DEVELOPMENT MANAGEMENT COMMITTEE 18th JULY 2022

Case No: 22/00145/S73(REMOVAL/VARIATION OF CONDITIONS)

Proposal: REMOVAL/VARIATION OF CONDITIONS 3 (MATERIAL), 4 (LANDSCAPE), 5 (LEVELS), 6 (ECOLOGY), 7 (TREE PROTECTION), 10 (ARCHITECTURAL DETAILS) TO 18/01946/FUL AS THE MAJORITY OF THE WORKS ARE NOW COMPLETE ON SITE

Location: 50 HAMERTON ROAD ALCONBURY WESTON PE28 4JD

Drawing Title -
Plot 1 - Elevations
Client - RHD Homes
Address - Salix House, Hamerton Road, Alconbury Weston
Scale - As shown at A1 Date - JAN 21
Dwg. No. - JPT/RHD/0121/002 Rev. C

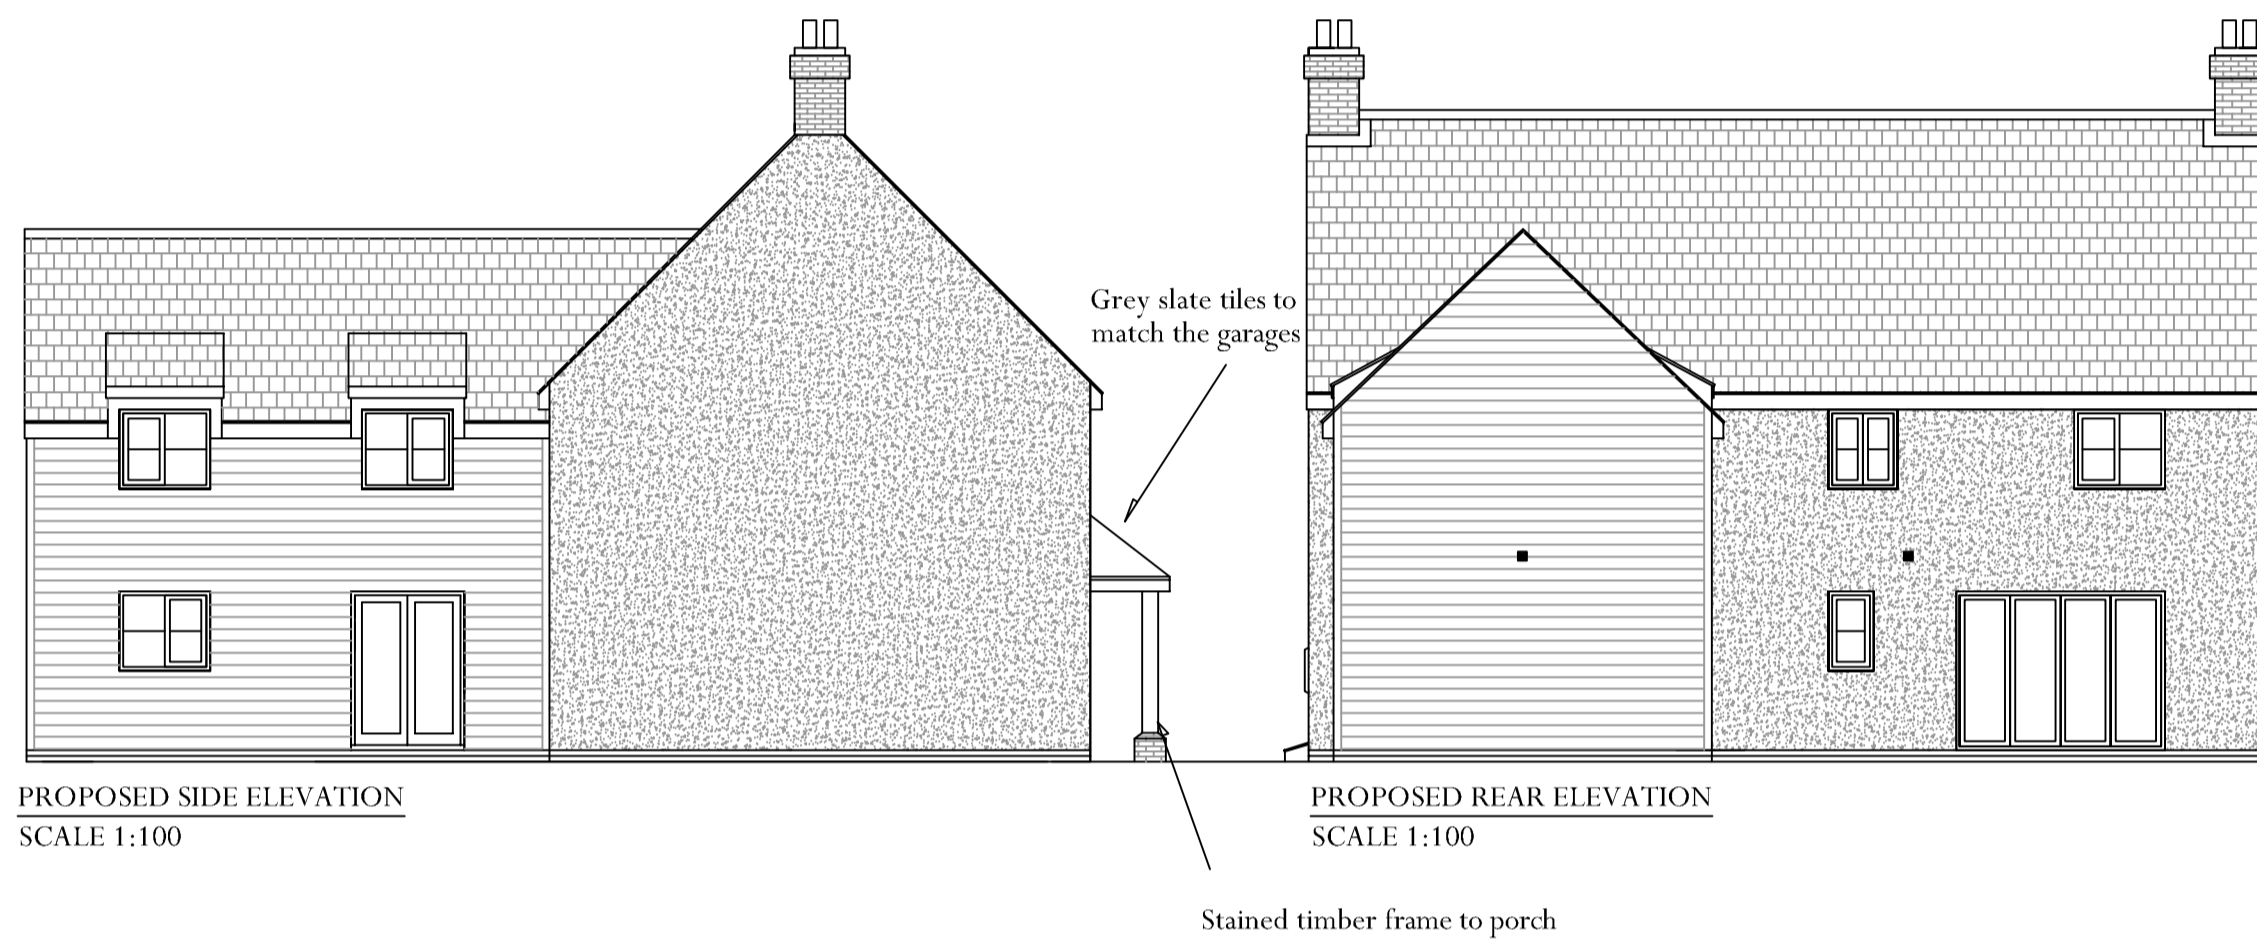
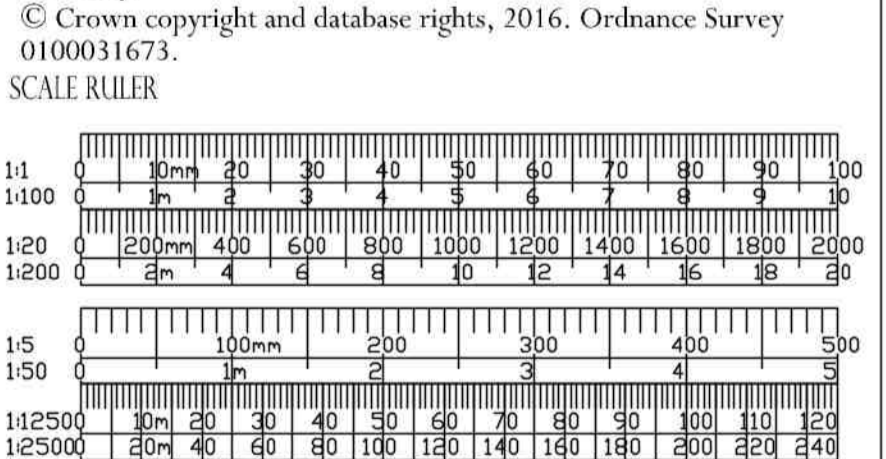
Plot 1 - dwg JPT/RHD/0121/002 (replaces approved dwg JTP/PB/0318/002 Rev B)

The proposed materials are set out on dwg JPT/RHD/0121/004 are acceptable. The introduction of the side entrance door is acceptable. The location of the white meter box is accepted. Amendments are required to introduce chimneys (2 chimneys – one on either gable) to articulate the roof line as well as window head details as per approved elevations – these are shown missing from the case officer site photos. Consider if brick slips could be used to create the appearance of window heads (C10). Details of the window reveal depth should be confirmed (C10) – these appear very shallow on the site photos and we question if window reveal depths could be increased (windows setback further) prior to the installation of the render.
